III. REVISIONS, CLARIFICATIONS, AND CORRECTIONS TO THE DRAFT EIR

Fourth & Central Project

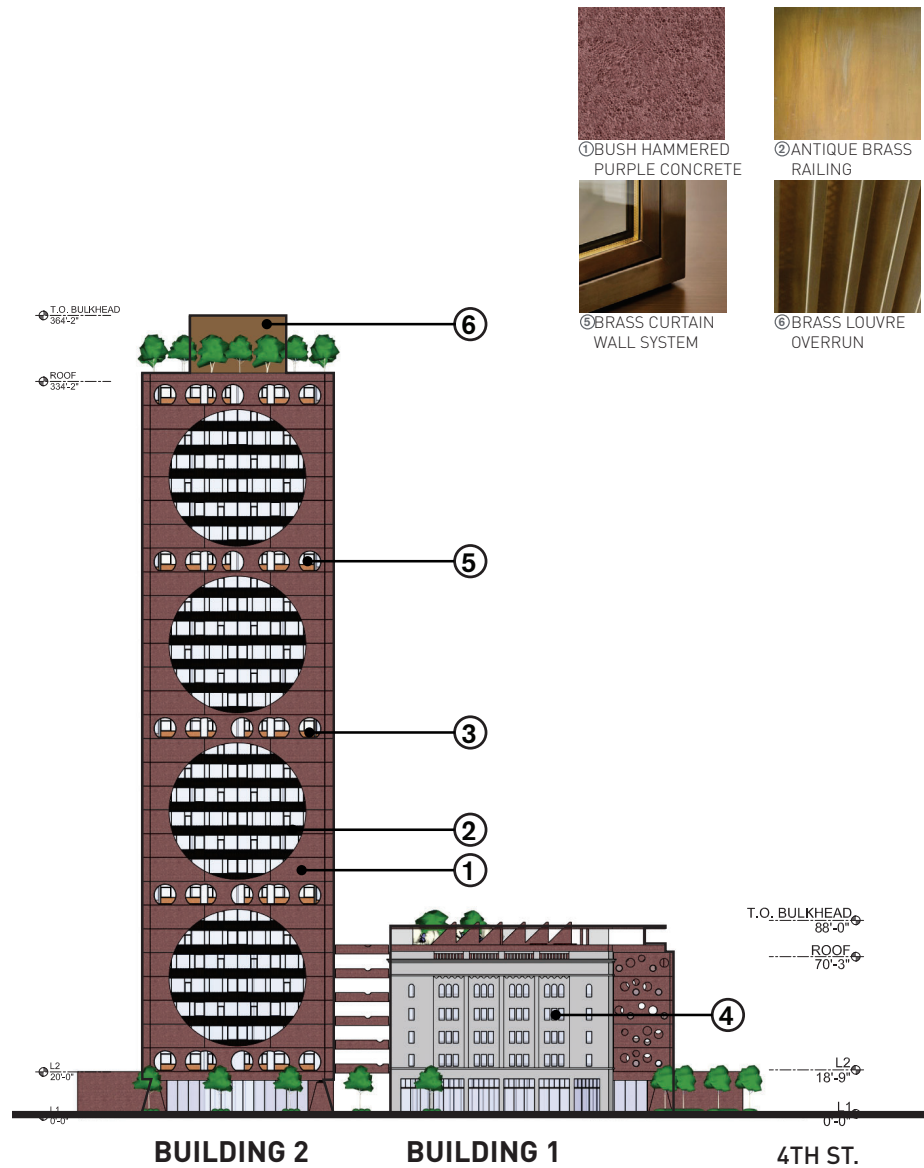
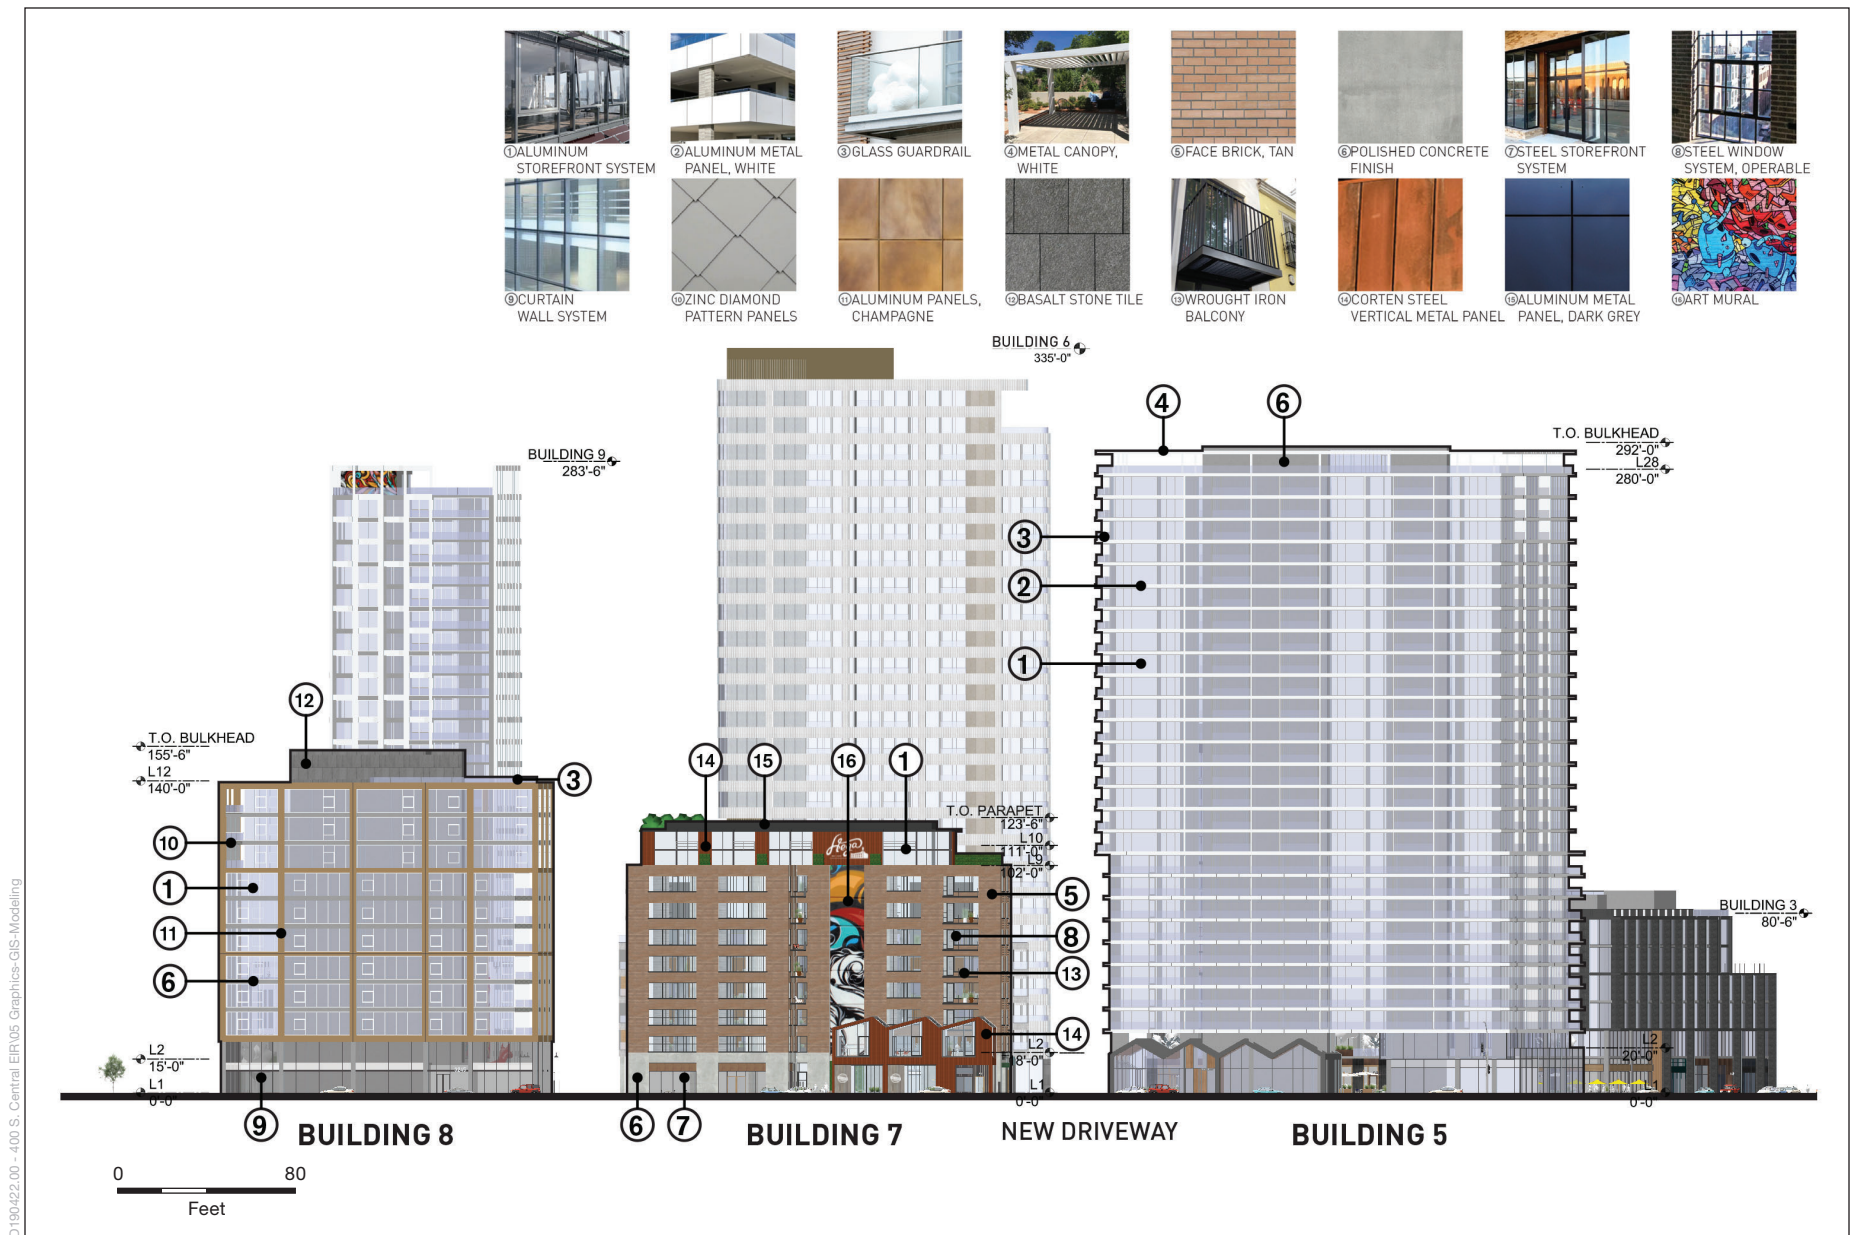
22. Pages II-29 to II-34, Subsection 4.a)(2), *Architecture and Design*, revise the following figures: Figure II-14, *Conceptual Aerial View Toward Downtown Los Angeles*; Figure II-15, *View of Central Avenue at 4th Street*; Figure II-16, *View of Central Courtyard*; Figure II 17, *North Site Exterior Building Materials – Viewed from Central Avenue*; Figure II-18, *South Site Exterior Building Materials – Viewed from Central Avenue*, and Figure II-19, *South Site Exterior Building Materials – Viewed from Alameda Street*.

Figure II-21
Overall Tree Planting Plan

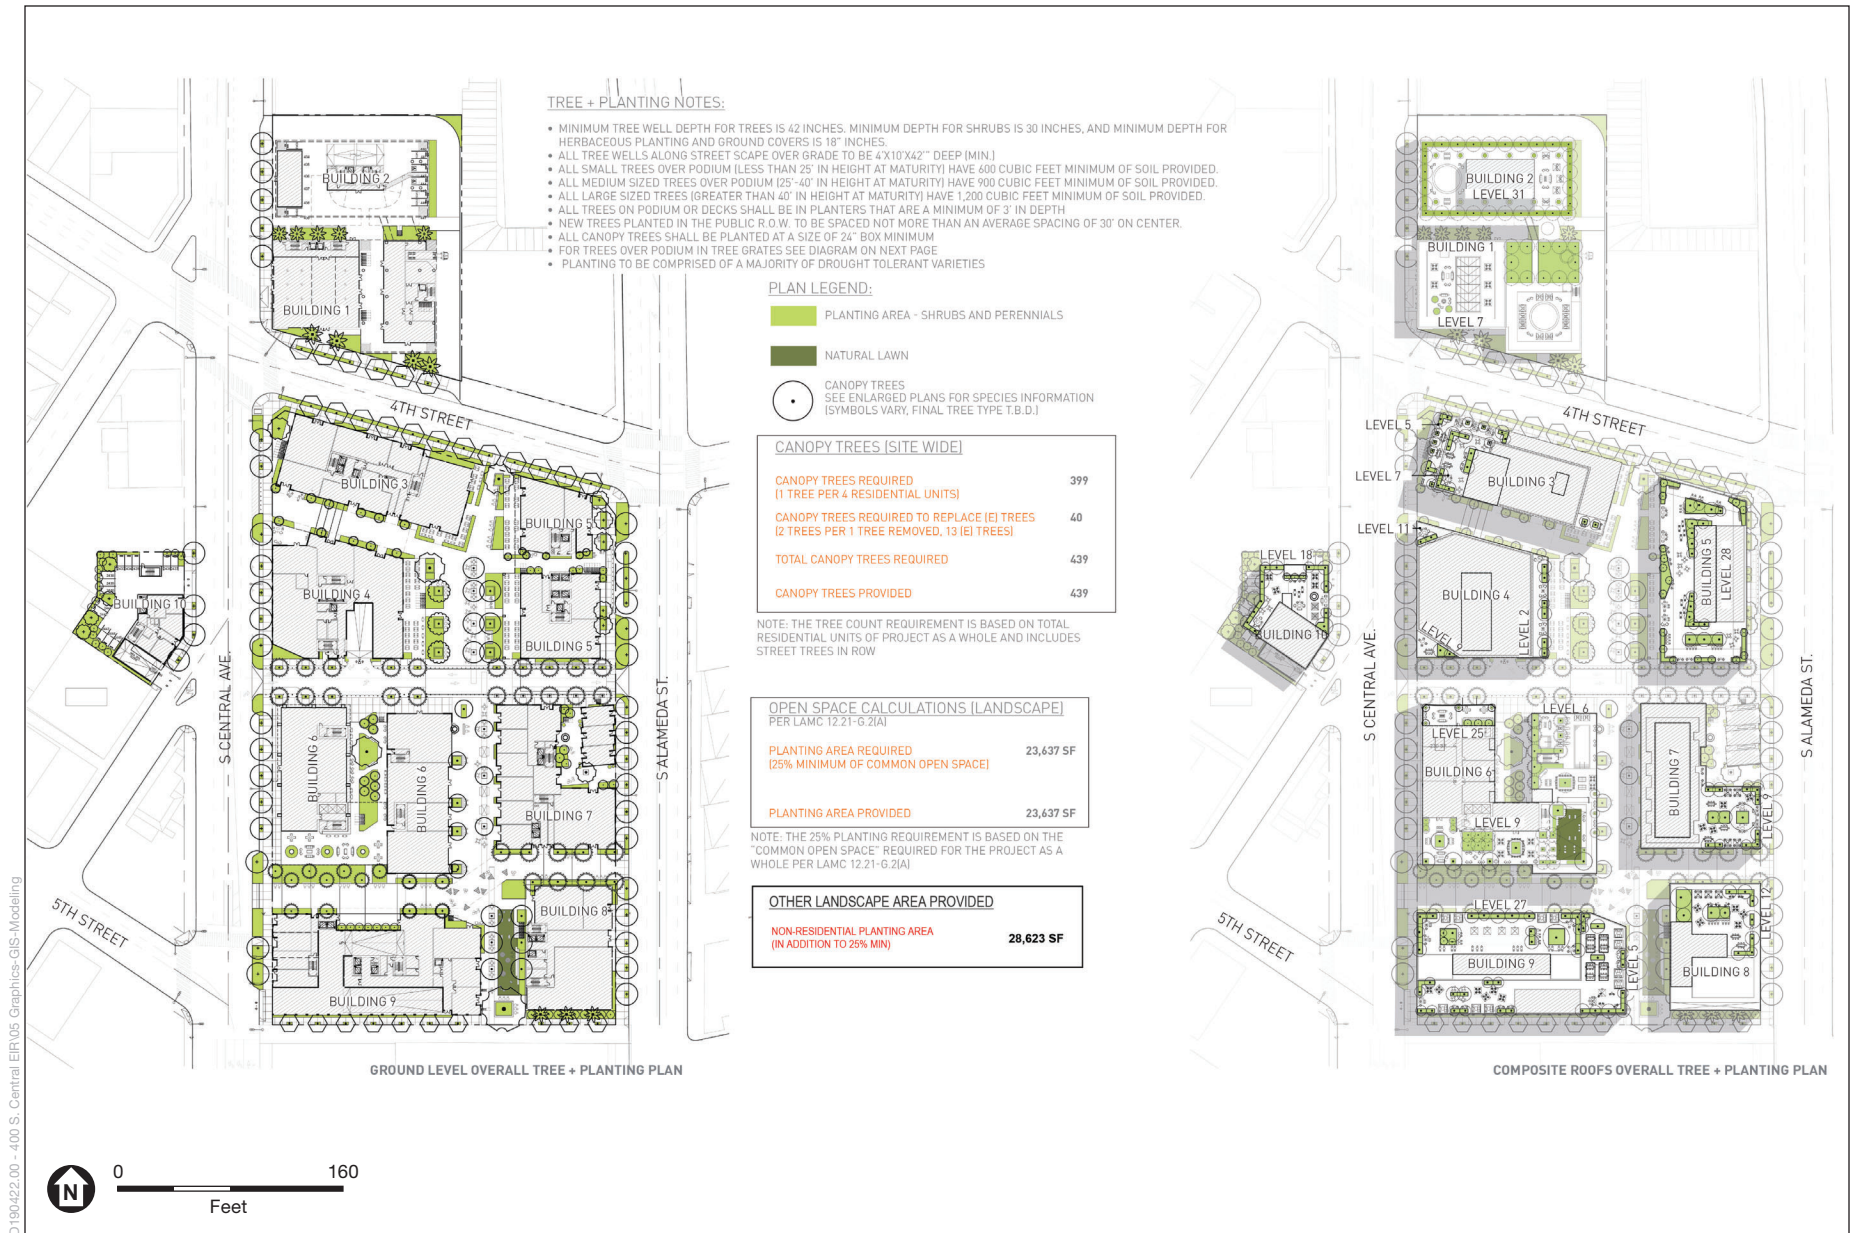
The residential uses would generate a requirement of ~~382~~ 399 trees to be provided within the Project Site. In addition, the existing 20 street trees to be removed during Project construction would be required to be replaced at a 2:1 ratio for a total of 40 replacement trees. Overall, the total tree planting for the Project would require ~~422~~ 439 new trees which the Project would provide. Tree placement is illustrated in **Figure II-21, Overall Tree Planting Plan**.

29. Page II-45, Subsection 4.a)(3), *Landscaping and Open Space*, revised Figure II-21, *Overall Tree Planting Plan*.
